Memorandum Department of Planning & Public Works

RE: P.Z. 03-2010 Suburbia Gardens (40-Timberlake SE, LLC): A request for a new

Planning Commission Vote Report

Petition: P.Z. 03-2010 Suburbia Gardens (40-Timberlake SE, LLC)

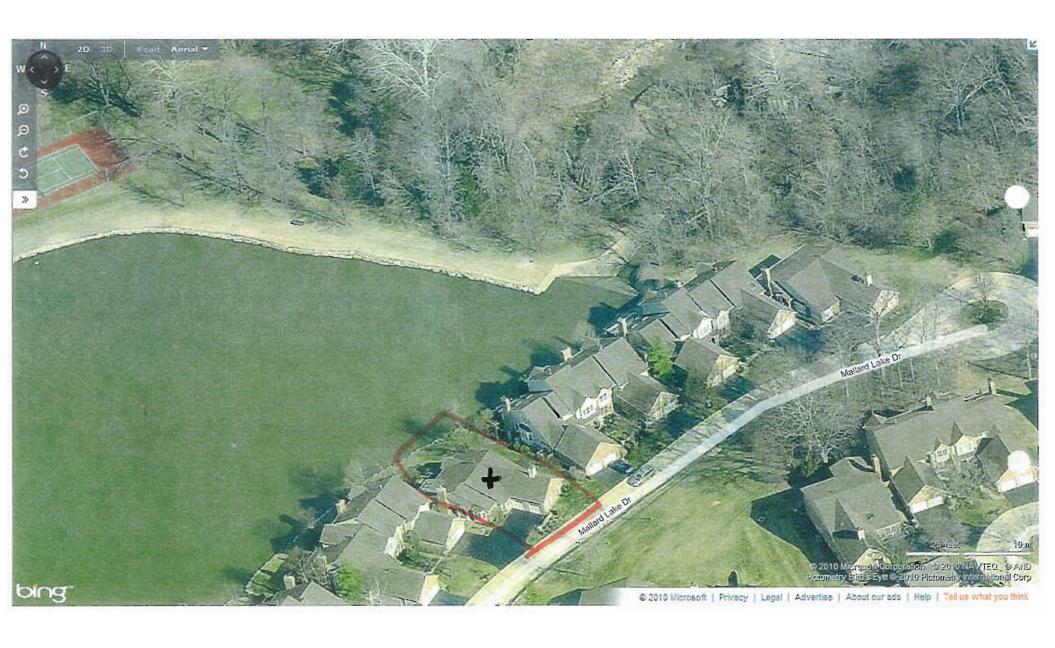
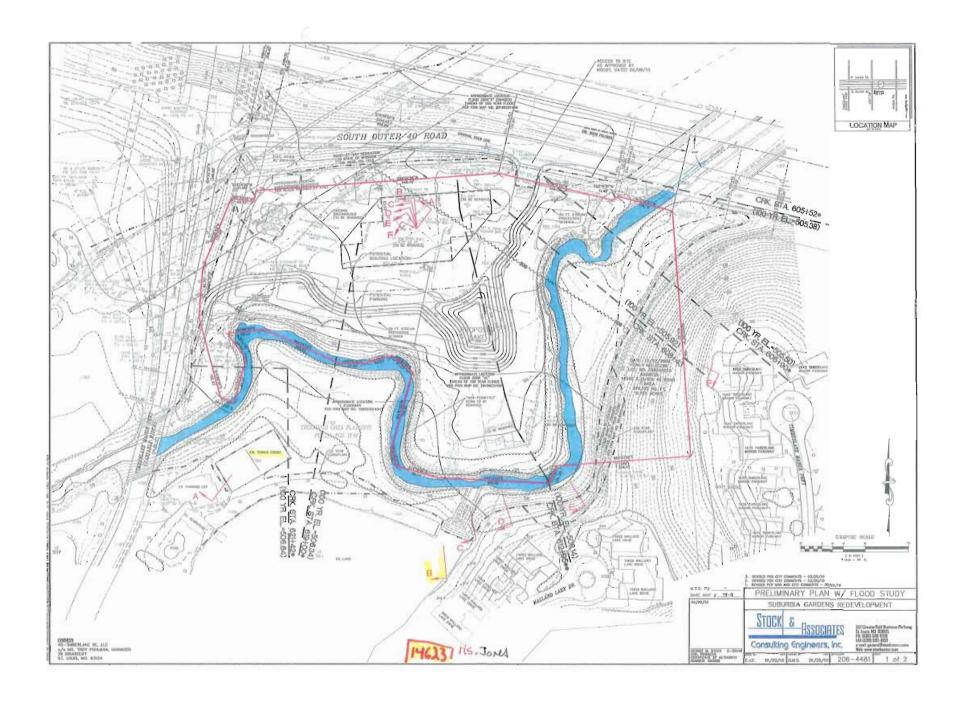
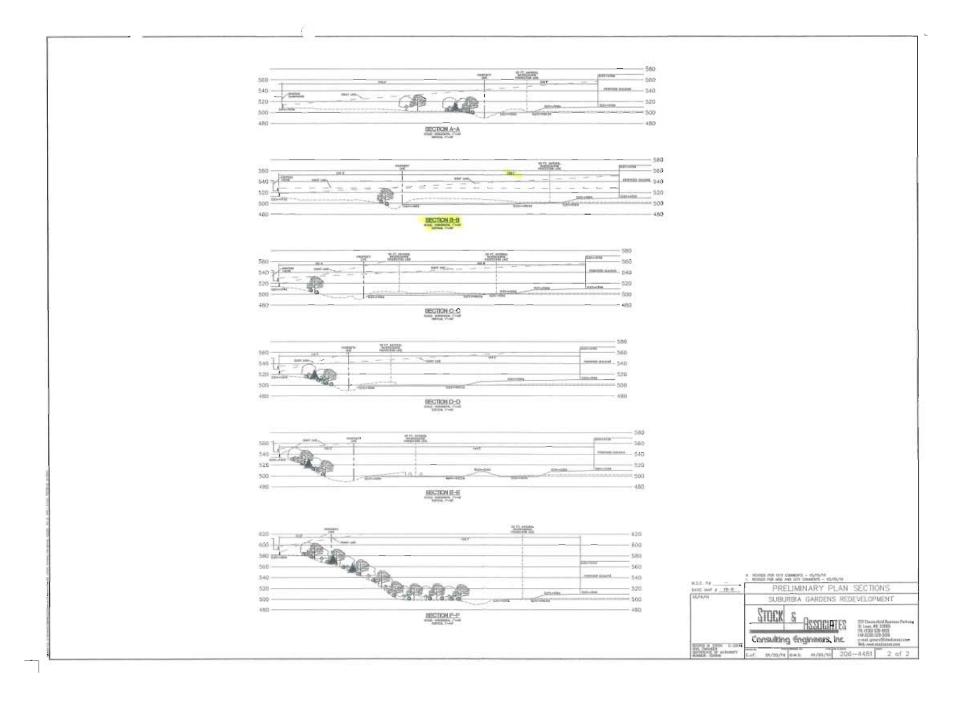
As a resident of The Townes of Thousand Oaks and an owner of a townhome which is on the lake only a few properties away from the proposed development, I would like to ask the Planning Commission to seriously consider restricting the use of the subject land.

My request is to deny approval of any type of 24-hour business; specifically a nursing home. I acknowledge it is true that all emergency situations (regardless of type of building) will require ambulances. However, it is reasonable to assume that a nursing home population of individuals who are elderly, sick and unable to care for themselves has an increased likelihood of need for ambulance traffic, and/or family visitors during emergency situations producing noise at all hours of the day or night.

To provide maximum visual screening of/from the proposed building and to ensure privacy of homeowners' decks and interiors as well as provide increased noised reduction, it is requested the Planning Commission seek the developer's agreement to increase the number of trees along the southern border existing tree line.

the amount of water that will be displaced when 3.87 acres of flood plain (land which regularly floods) is developed; water which a retention pond cannot possibly, totally, absorb,

We are in receipt of a letter written to Ms. Mara Perry dated 6/28/10 from Ms. Carol Jones, Resident at 14623 Mallard Lake Drive. (See attached drawings for home location.)

First, "Nursing Home Use". We disagree that a nursing home provides the potential of increased noise and light intrusion. Should a "nursing home project" move forward, that project will have to go thru a "Detail Site Plan and Architectural Review" process with the City, and address "all" potential issues. However, we believe that this zoning request has set forth specific performance criteria relative to site design, density, open space and buffer setbacks to prevent any future development issues as described from Ms. Jones' letter.

Secondly, "Tree Buffer". The intent of development of this property is to preserve as much of the trees and vegetation along the south and east borders of the property. There will be no disturbance of the creek, with the exception of the north and west bank of the creek to remove the illegal berm constructed. This area will then be restored as a "Riparian Corridor".

Thirdly, "Flood Concerns". We will continue to work with the City, The Metropolitan St. Louis Sewer District to seek approvals and sponsorship for a submittal to FEMA as part of a "CLOMR" – Conditional Letter of Map Revision Application.
